GROUP Safety Recall Campaign	MODEL 2015-2018MY Sedona (YP)
	NUMBER SC175	DATE March 2019
SAFETY RECALL CAMPAIGN		
SUBJECT: FRONT PASSENGER SEAT OCCUPANT DETECTION SYSTEM (ODS) WIRING HARNESS (SC175)

FRONT PASSENGER SEAT OCCUPANT DETECTION SYSTEM (ODS) WIRING HARNESS (SC175)

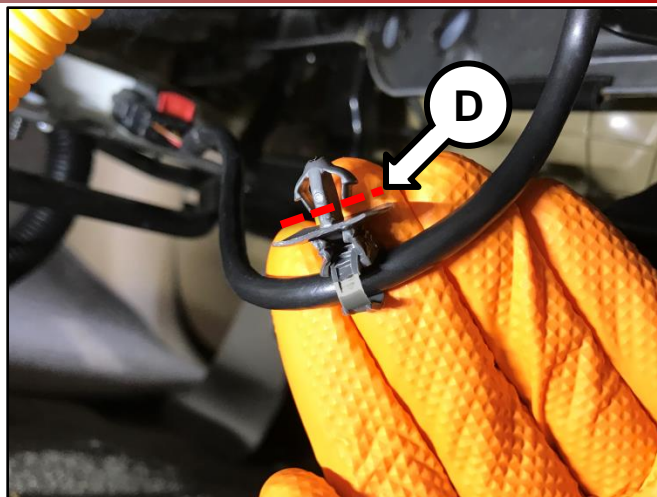
4. Carefully cut the retaining clip between the wiring harness and the clip head (D) using side-cutter pliers and discard the clip head. Allow the wiring harness to move freely. Do not replace the retaining clip or secure the harness.

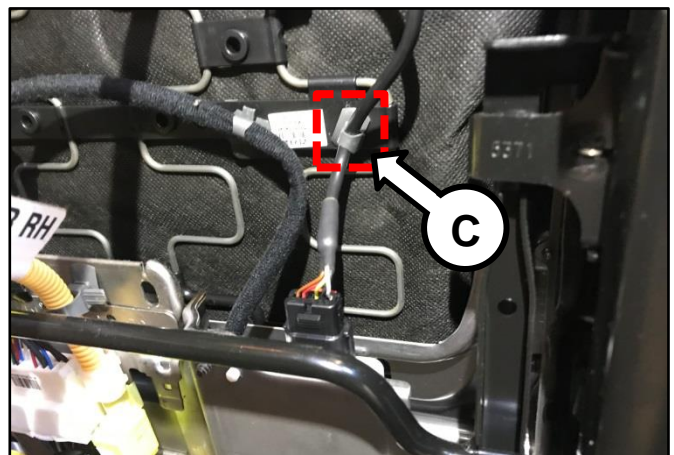
2. Replace the front passenger cushion (D) by referring to **steps 1 through 7** of the "Body (Interior and Exterior) → Front Seat → Front Seat Cushion Cover → Repair procedures" chapter in the applicable Shop Manual on KGIS.

NOTE: DO NOT secure the ODS wiring harness at the retainer (C).

**Seat Retaining Bolt Tightening torque:
32.5 – 43.4 lb.ft (44.1 – 58.8 N.m,
4.5 – 6.0 kgf.m)**
